SUBJECT: TECHNICAL SPECIFICATION CHANGES TO SUPPORT CYCLE 4 RELOAD
(TAC NO. 65636)

RE: SUSQUEHANNA STEAM ELECTRIC STATION, UNIT 1

AMENDMENT TO FACILITY OPERATING LICENSE

Amendment No. 72
License No. NPF-14

MAXIMUM AVERAGE PLANAR LINEAR HEAT GENERATION RATE (MAPLHGR) VERSUS AVERAGE BUNDLE EXPOSURE ANF 9X9 FUEL FIGURE 3.2.1-3

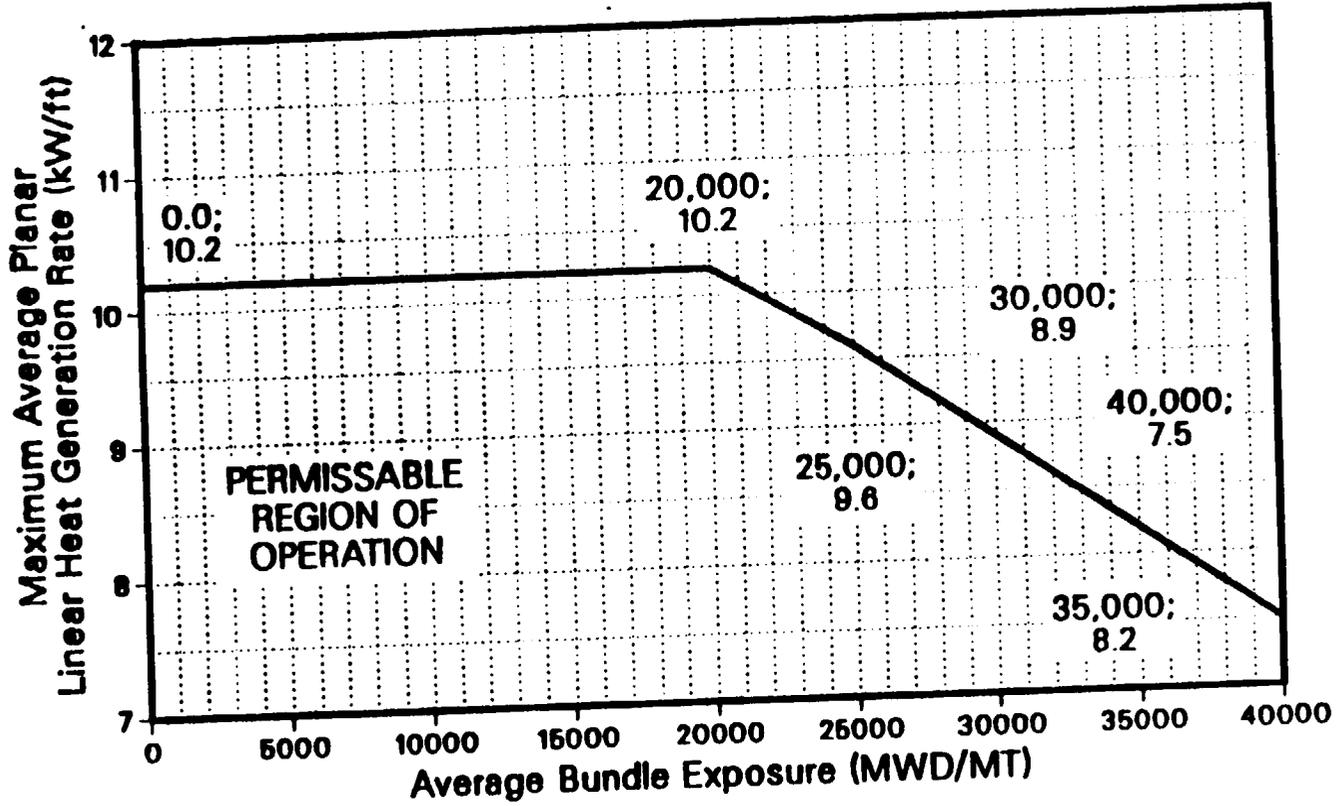
(3) Figure 3.2.1-3:

The MAPLHGR limits for the new fuel are added. This addition is acceptable.

**FLOW DEPENDENT MCPR OPERATING LIMIT
FIGURE 3.2.3-1**

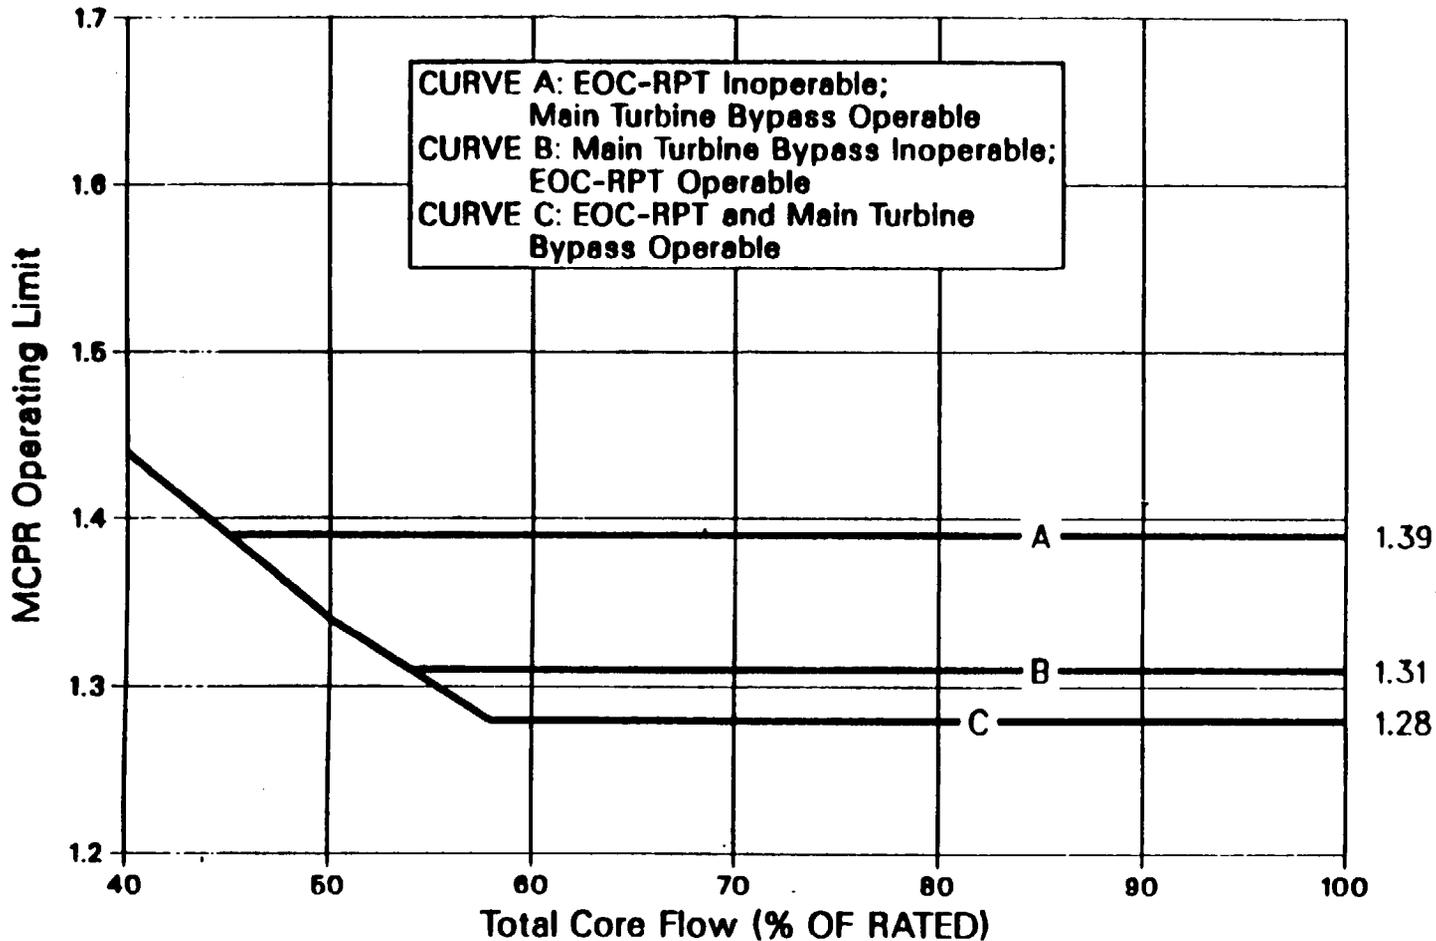
(5) Figure 3.2.3-1 and 3.2.3-2 and LCO page 3/4 2-10a:

LINEAR HEAT GENERATION RATE (LHGR) LIMIT
VERSUS AVERAGE PLANAR EXPOSURE
ANF 9X9 FUEL
FIGURE 3.2.4.2-2

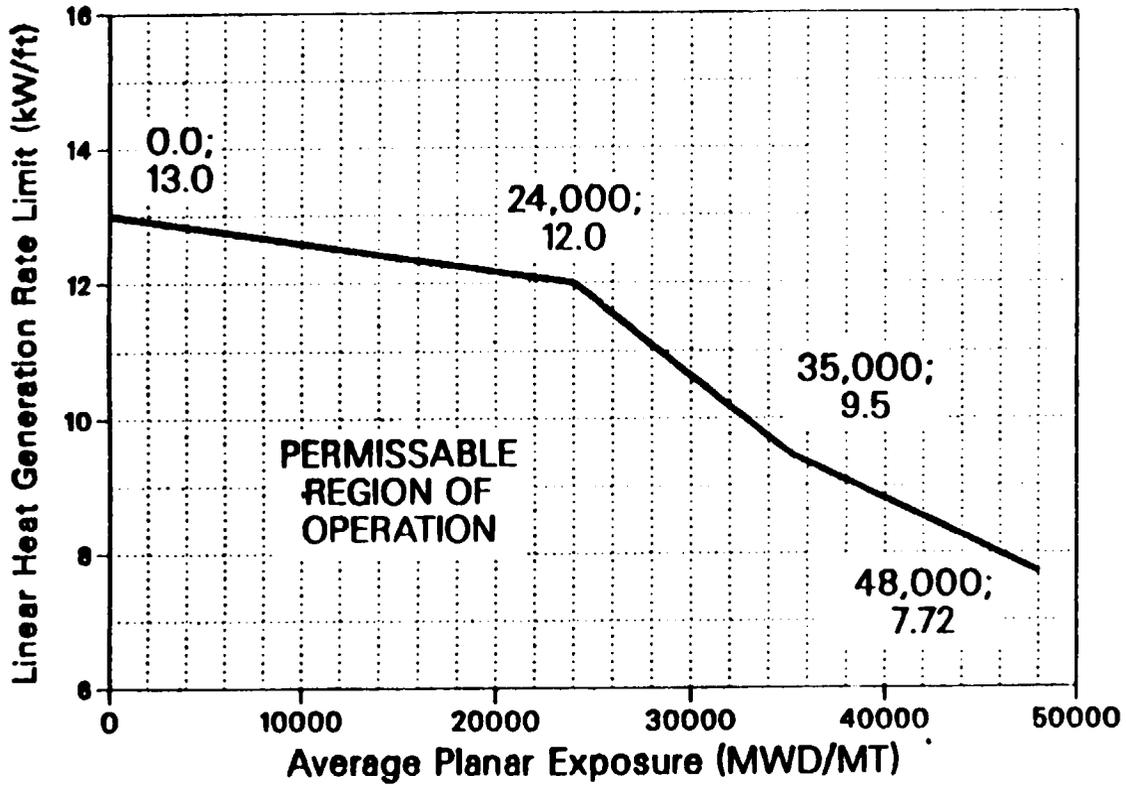
The licensee has provided a figure of LHGR Limit vs Planar Exposure for the ANF 9X9 fuel to be incorporated into the SSES Unit 1 Technical Specifications (Figure 3.2.4.2.-2). This Figure was approved in the staff's safety evaluation for licensing topical report XN-NF-85-67(P), dated July 23, 1987, and reflects the design values which have been previously reviewed and approved. Based on the results of the generic review we find the LHGR limits for the 9X9 fuel to be acceptable. This acceptability also applies to the exposure-dependent LHGR provided in proposed Figure 3.2.2-1 which is based on ANF's "Protection Against Fuel Failure" concept which was also part of the generic review.
